SUBDIVISION COMMITTEE
METROPOLITAN AREA PLANNING COMMISSION

STAFF REPORT
(Preliminary Plat)

CASE NUMBER: S/D 95-58 MEADOW OAKS 3RD ADDITION

STAFF REPORT

VICINITY MAP:

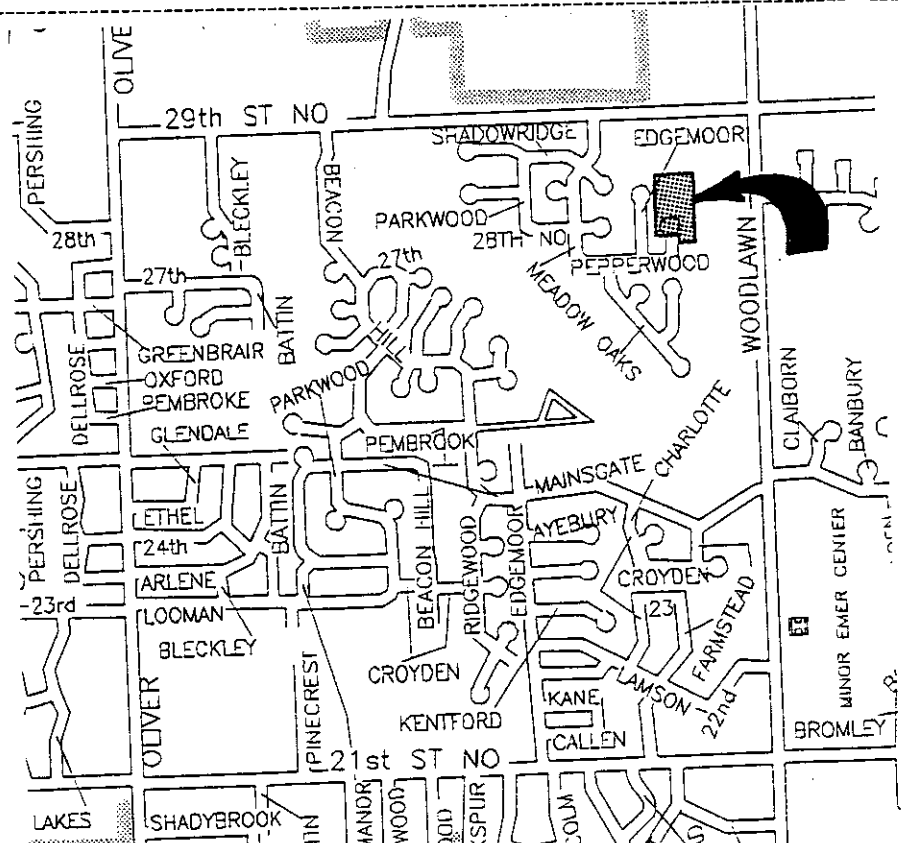
- A. The applicant is advised that the portion of lot (Lot 1, Block 1, Meadow Oaks Addition) not being included in this replat will not be eligible for a building permit without being replatted itself. That is, since that original lot is being resubdivided (southern portion) into several building sites, the remaining portion of the lot cannot be built upon until it is replatted nor can a lot split be approved under these conditions.

- B. The applicant shall guarantee the extension of sanitary sewer to serve the lots being platted.
- C. The applicant shall guarantee the extension of City water to serve the lots being platted.

- D. The applicant shall guarantee any drainage improvements required by the platting of this property.
- E. The applicant shall guarantee the paving of the proposed interior streets.

- F. **City Engineering** needs to indicate if there are any projects or associated costs needing to be recovered due to the abandonment of projects as a result of this replat.

- H. The applicant shall submit a covenant which provides for four (4) off-street parking spaces per dwelling unit on each lot which abuts a 58-foot street. The covenant shall inventory the affected lots by lot and block number and shall state that the covenant runs with the land and is binding on future owners and assigns.

- I. On the final plat, the southern line of this site as it crosses Pepperwood Cir. shall be shown as a dashed line since solid lines of this type would only be used in cases indicating a private street.

- J. Since this is a replat, proper reference to KSA 12-512(b) as amended, shall be noted in the surveyor's text as to the vacation of street right-of-way, easements, setbacks, etc.

VICINITY MAP:

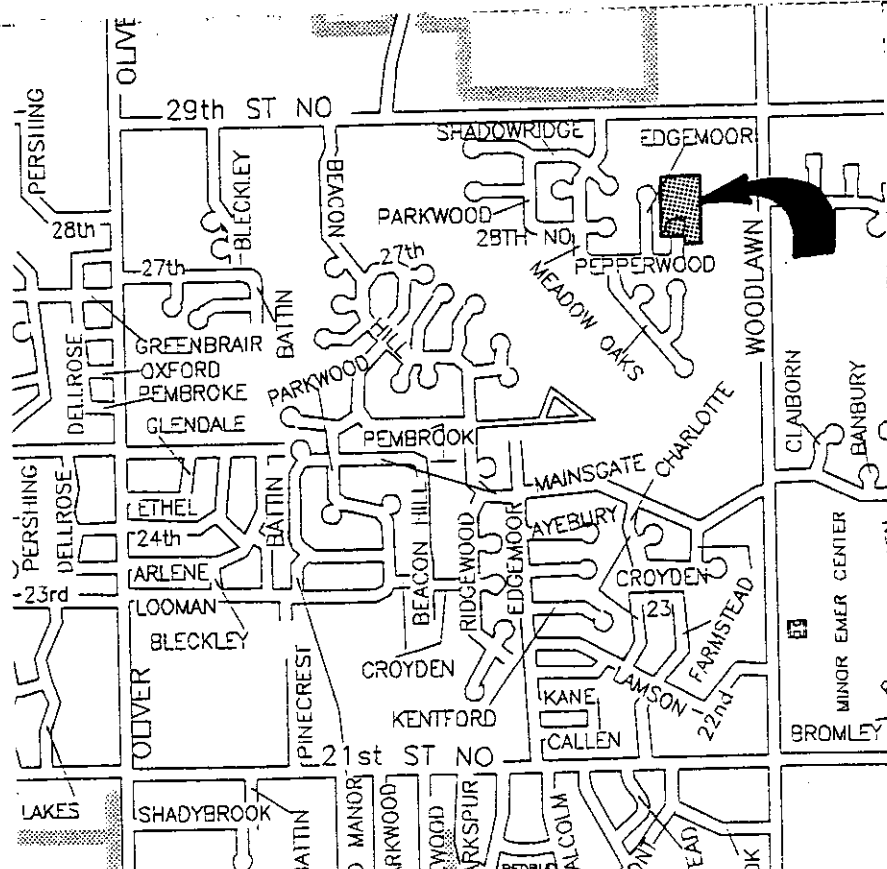
- H. On the final plat tracing, the utility easement along Lots 4 and 5's common lot line shall be clearly labeled as a 10-foot utility easement.
- I. That portion of the 20-foot easement along the north line of this plat, but off-site cannot be granted by this plat. A dedication by separate instrument shall be provided for recording with this plat. The final plat tracing shall note that the 10-foot, off-site portion of this easement has been "granted by separate instrument".

- J. On the final plat tracing, since no Reserve is being plated for this Addition, the reference to a reserve shall be deleted from the platting's text.

- Q. The representatives from **City Engineering** should be prepared to comment on the status of the applicant's drainage plan. Also, **Engineering** needs to indicate if the indicated minimum "low opening elevation" noted in the plat's text is required and if so, if the elevation shown is adequate. If required, this elevation shall also be shown in MSL and a note placed under the north arrow indicating that the Addition is subject to minimum building elevation(s).

- R. **The applicant** or **the agent** need to indicate why an additional lot was added at the southwest corner of this plat. That is, not just a result of a reconfiguration of the preliminary plat's lot lines but is apparently the inclusion of an area not originally within the preliminary plat's perimeter.
